SUPPLEMENTAL INSTRUCTION

PROJ.: **Boys and Girls Club Prince of Wales**
PROJ. No.: **1716**
DATE: **September 05, 2018**
S.I. No. **S.I. - 042**

1.1 TITLE
Revision to Parapet detail at Grid x2

INFORMATION BULLETIN

REVISED PARAPET AT WEST END OF GYM

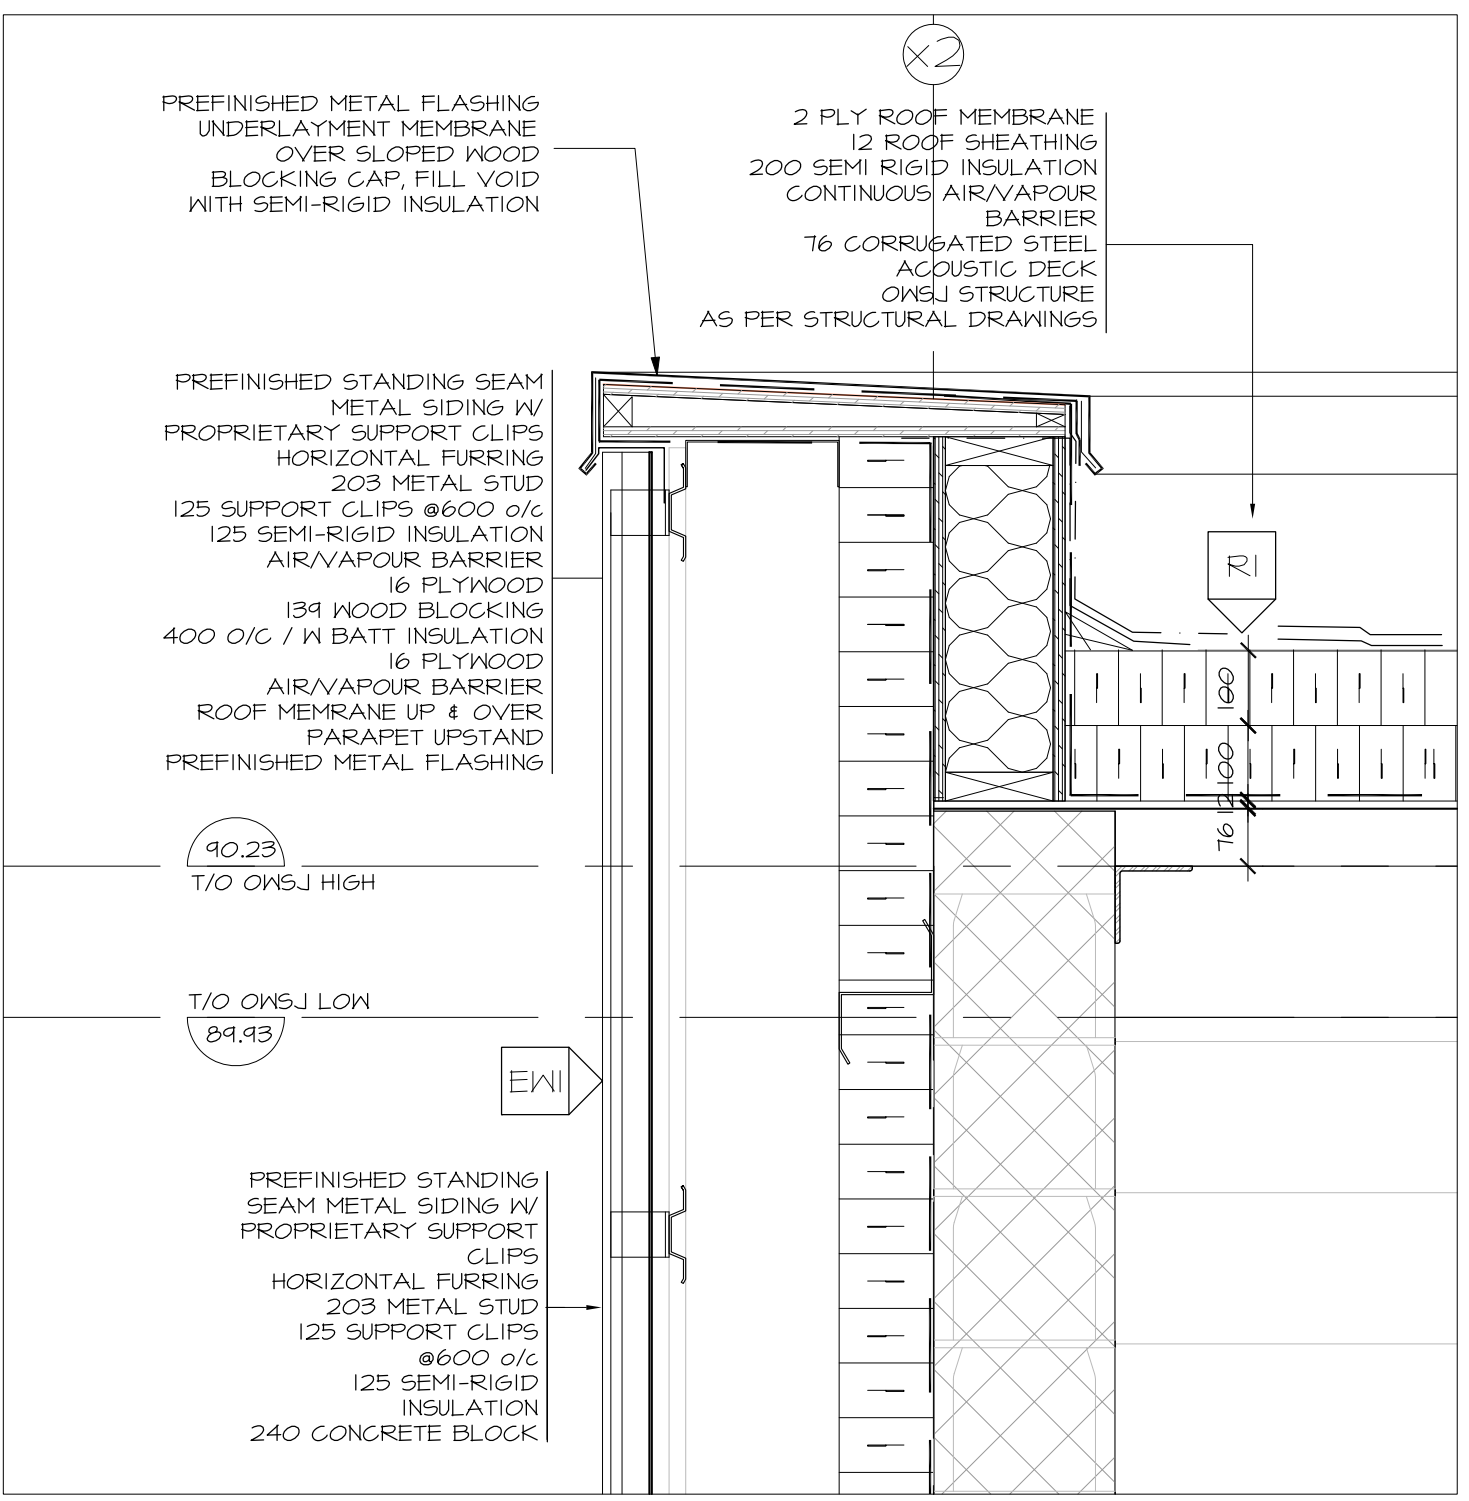
.1 Revise parapet detail at grid x2 from being block to being wood frame to accommodate as-built block condition and to make parapet similar to x2 at corners above the windows.

To accommodate as-built concrete block at parapet.
